Addendum

Date August 18, 2026
Project Name Oakland University – Aquatic Center Renovation 2027
TMP Project No. 26037
Addendum No. Three (3)

AQ3.0

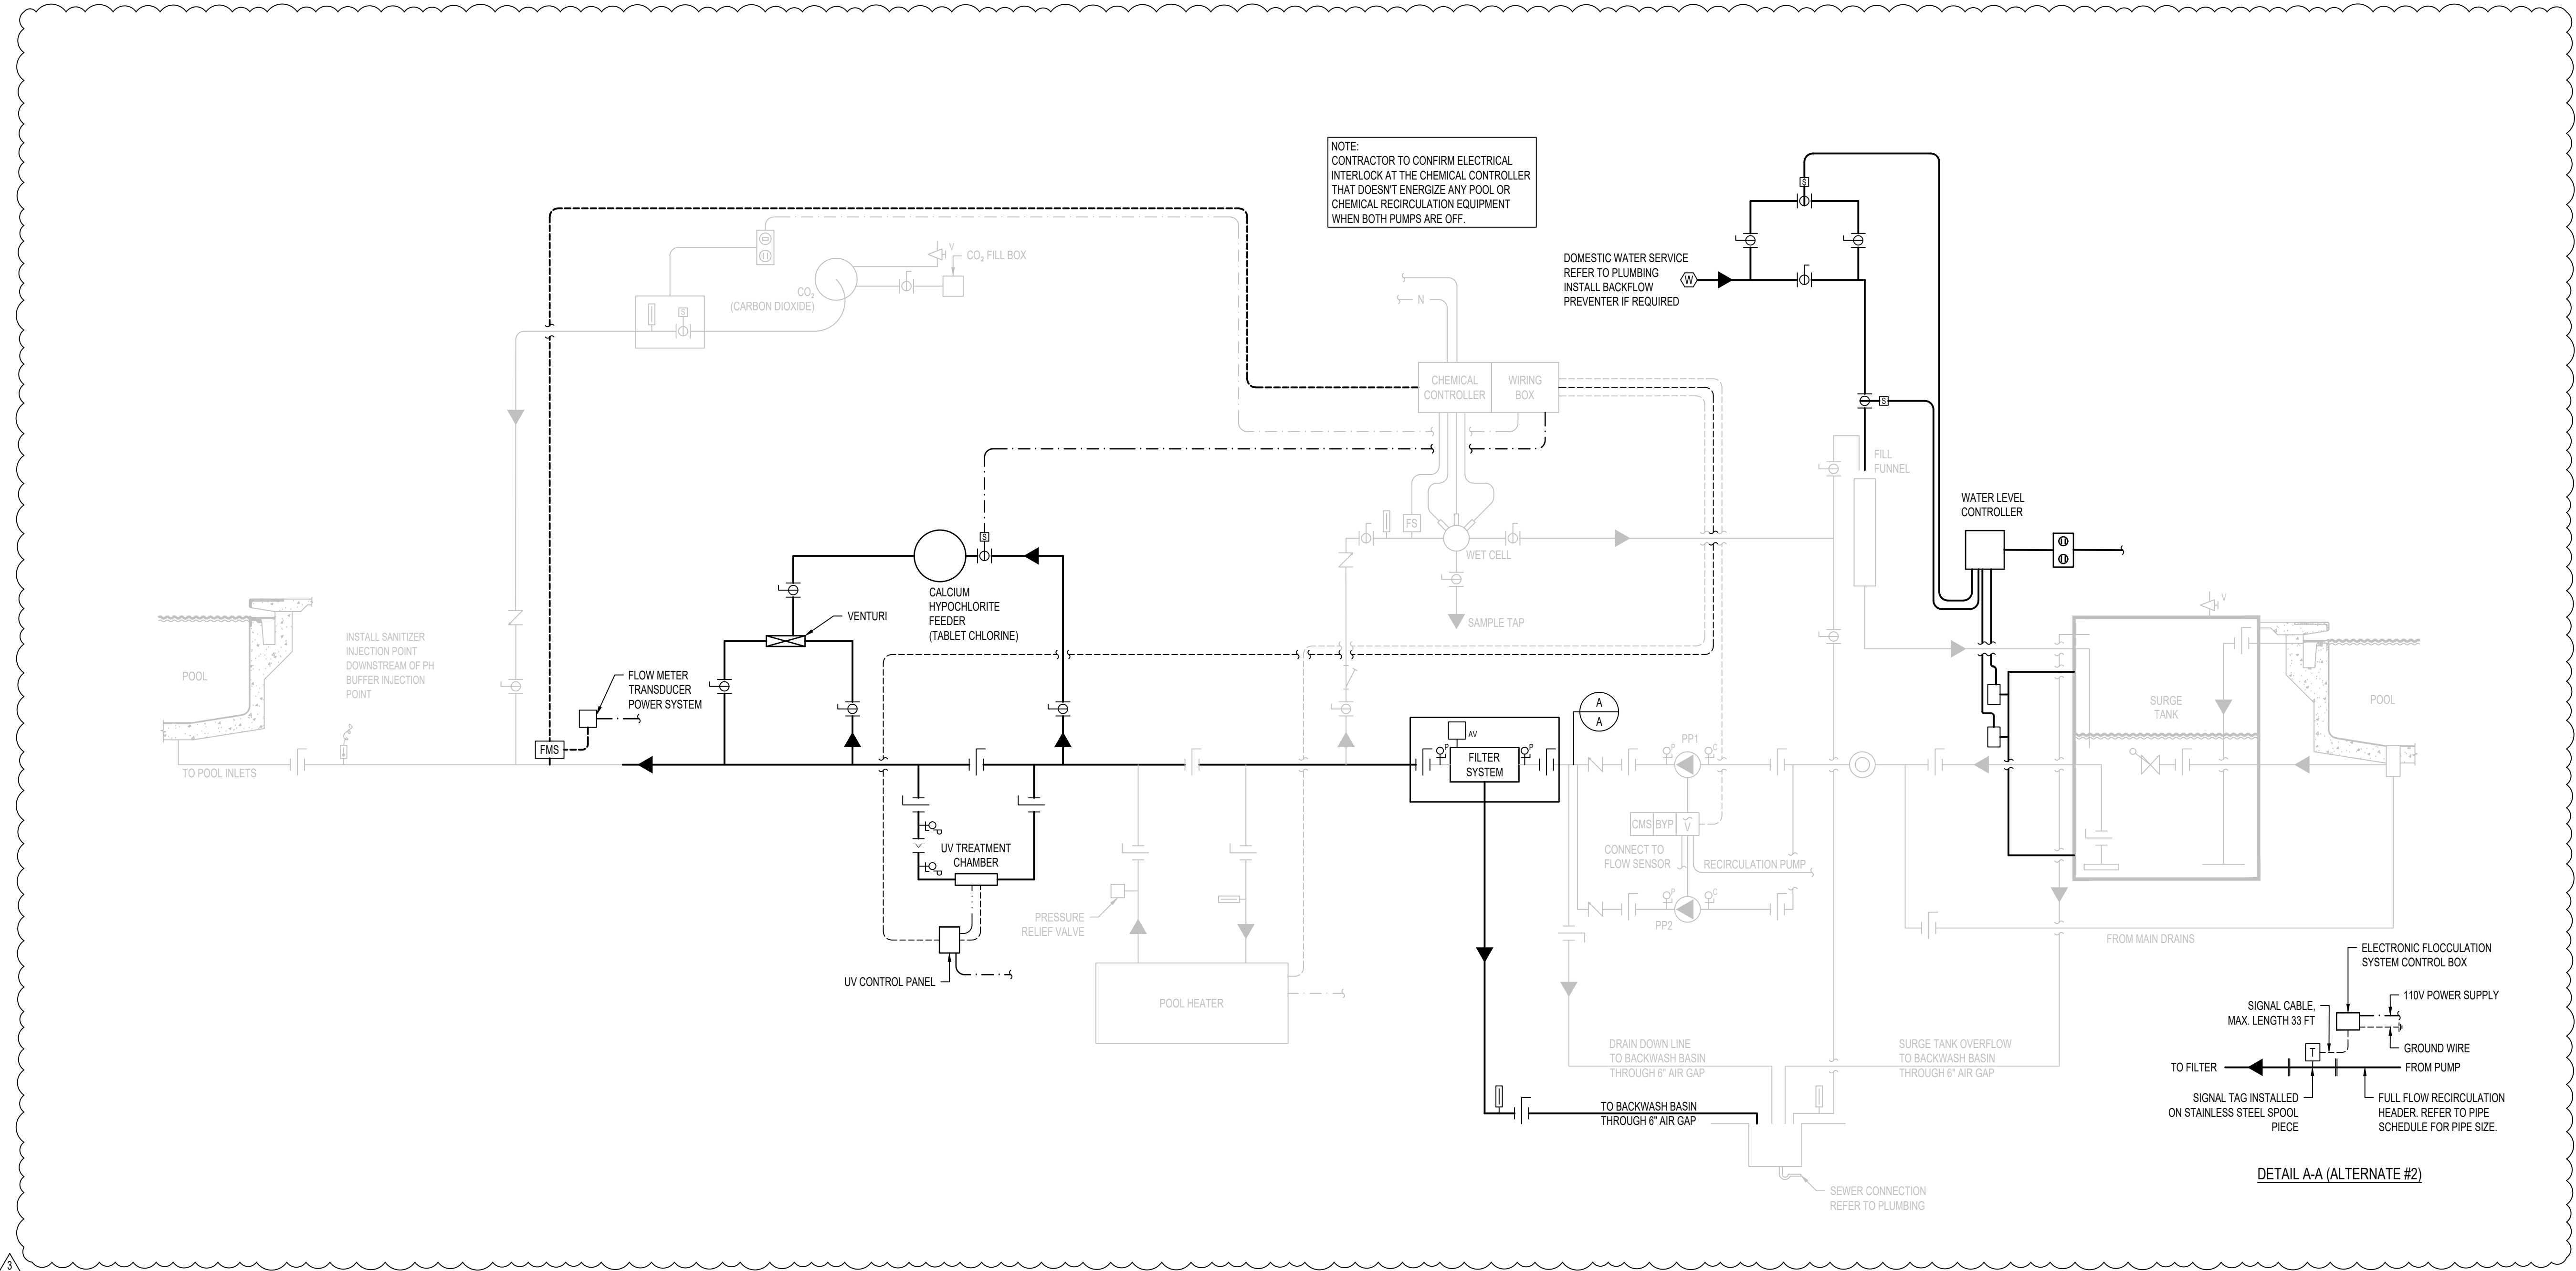
- AQ-8 Refer to Drawing No. AQ3.0 (reissued):
- A. Existing conditions clarified in systems schematic.
